From: Pfeiffer, Jane K - DNR
Sent: Tuesday, August 30, 2022 9:49 AM
To: Robert Reineke
Cc: Pratap Singh
Subject: RE: CWC- West Block (02-41-587376) VMS Commissioning Info Request

PROJECT TITLE: SITE INVESTIGATION REPORT
3212 W. CENTER ST., 2727 N. 32ND ST., 2758 N. 33RD ST.
COMMUNITY WITHIN THE CORRIDOR - WEST BLOCK
MILWAUKEE, WI 53210
PROJECT NUMBER: 40443

SHEET TITLE
Sub-slab Depressurization
Location and Results

FIGURE 1

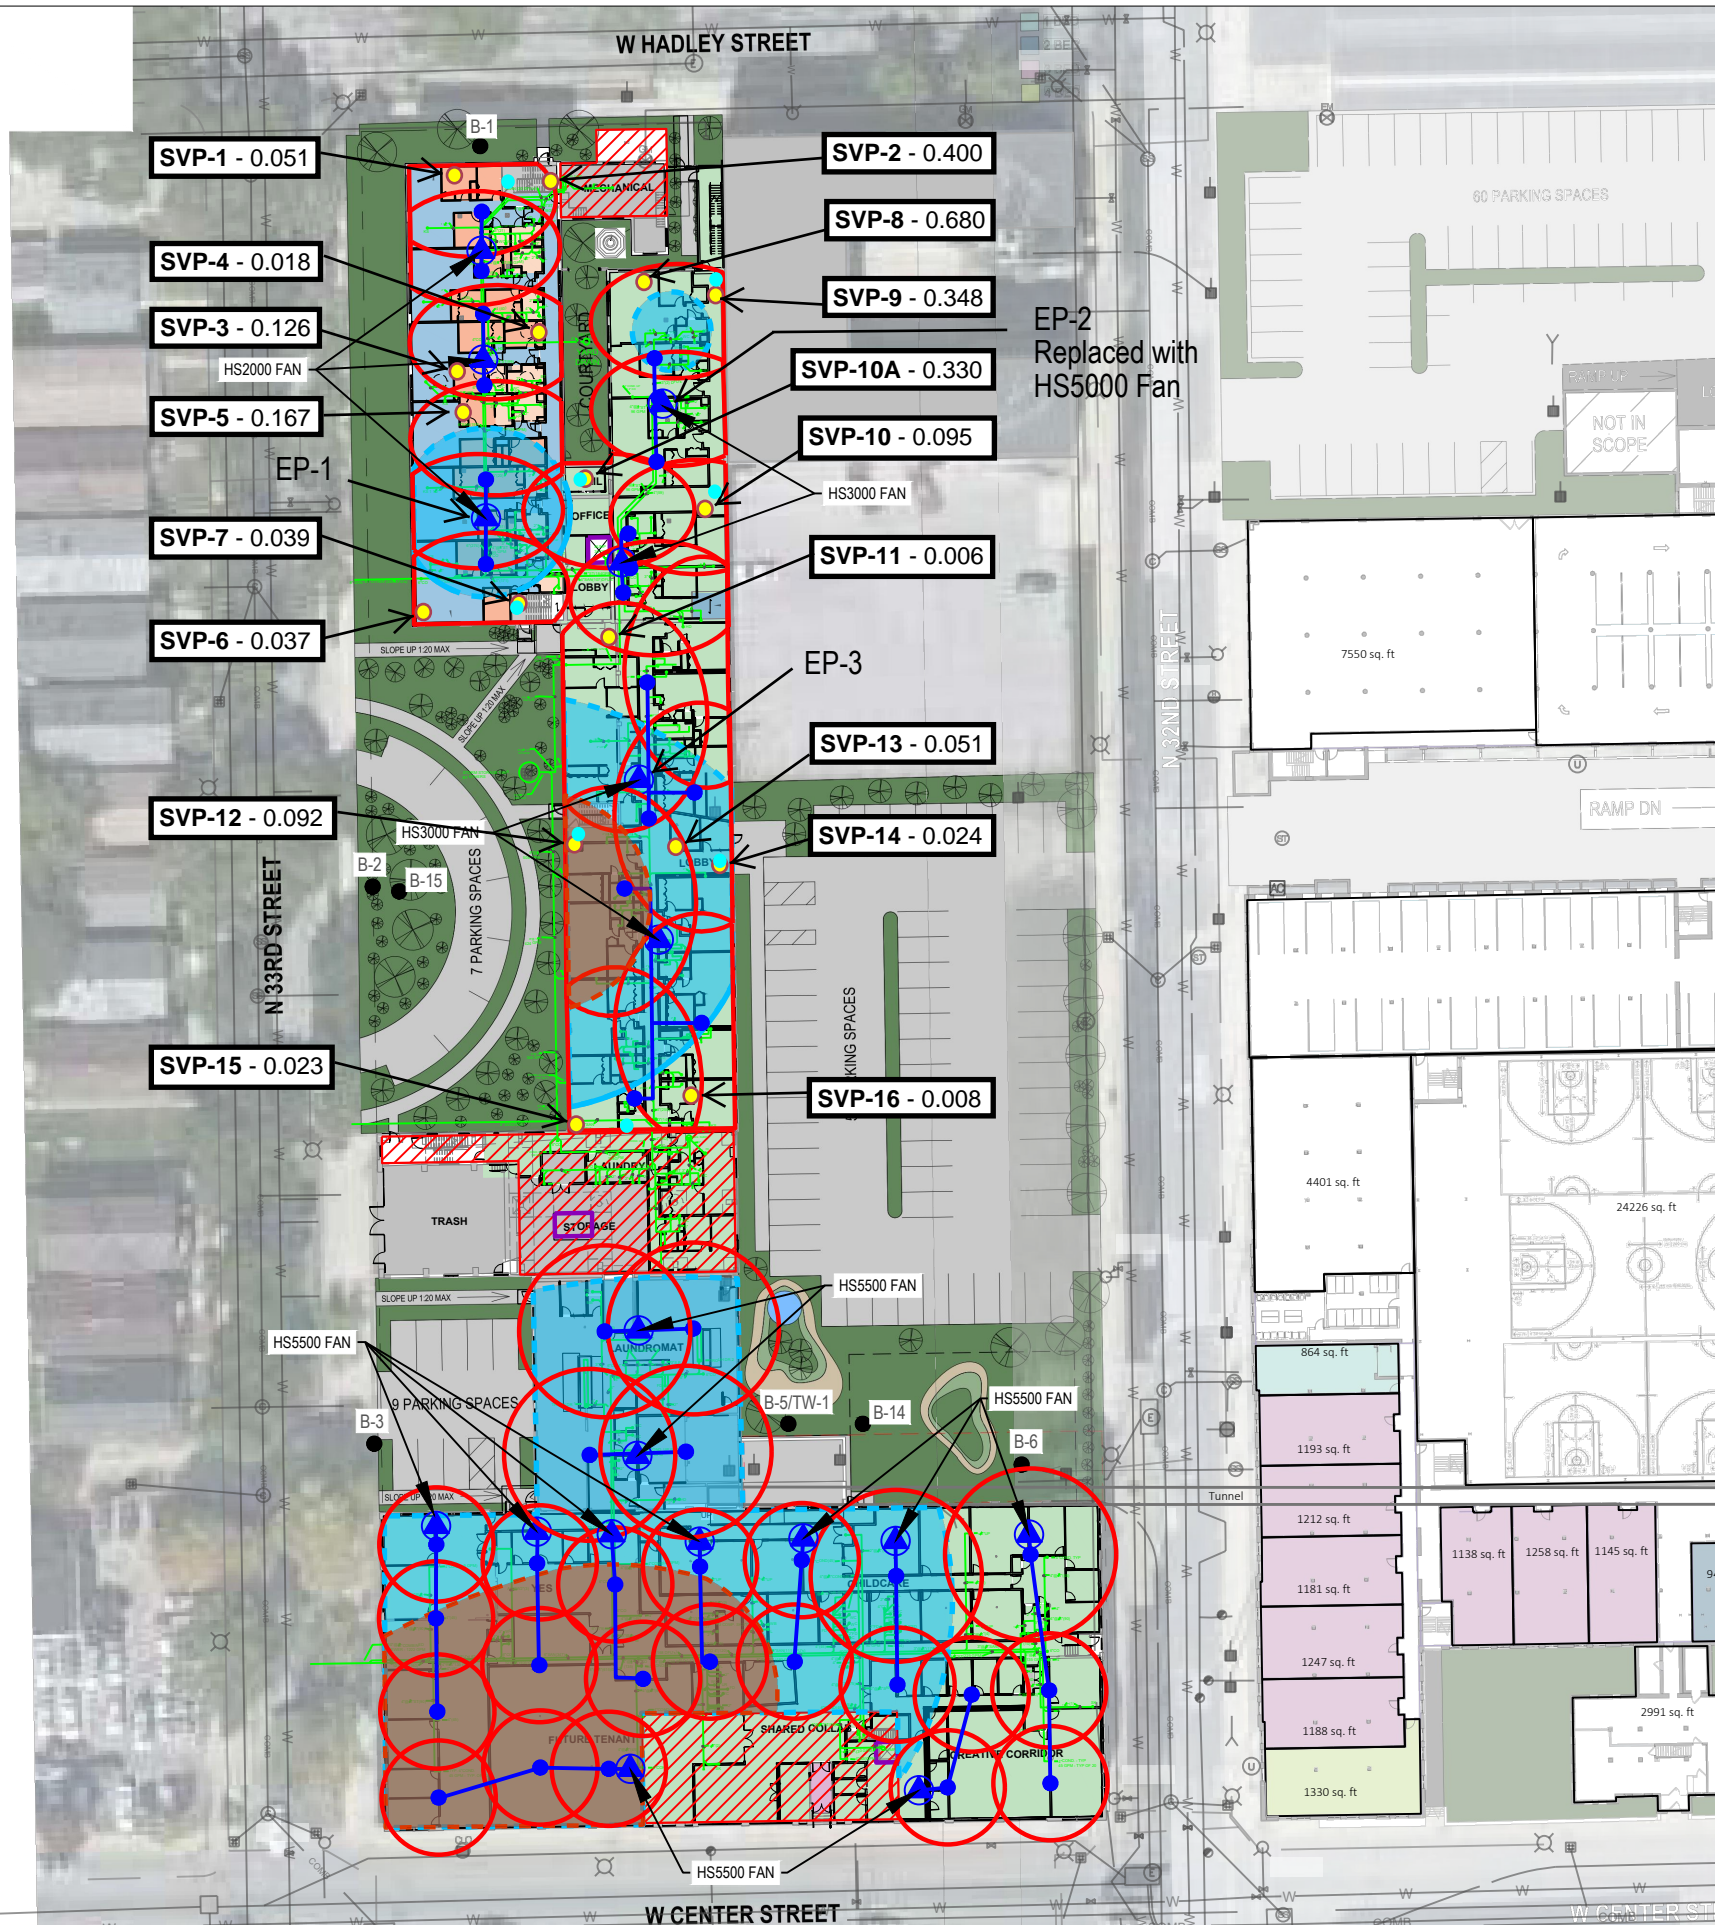
We are preparing to perform a 2nd round of commissioning at the Community Within the Corridor West Block in early September. To avoid damaging hardwood floors installed following the first round of commissioning, we are proposing to modify the commissioning plan for the location of subslab vacuum measurements. We are proposing to relocate the subslab sampling locations to concrete floor locations in accordance with the locations shown on the attached figure. We would appreciate WDNR consent for these modified locations for this round of commissioning.

I think I found a map showing the fan locations – Please confirm that the “exterior fan locations” shown on the attached figure are correct and that these are the locations where the exhaust samples were collected.

Can you please provide me with an update on the first round of commissioning for Buildings 4 and 5 for the above-referenced site? Has the commissioning occurred yet and, if so, when will the results be submitted to the DNR? Additionally, please present a figure that displays the locations of all of the fans (i.e., the exhaust sample locations) on the rooftops of Buildings 6, 7, 8A, and 8B.

Hi Robert – Thank you for speaking this morning with me concerning your below email. Please reach out if you have any further questions.
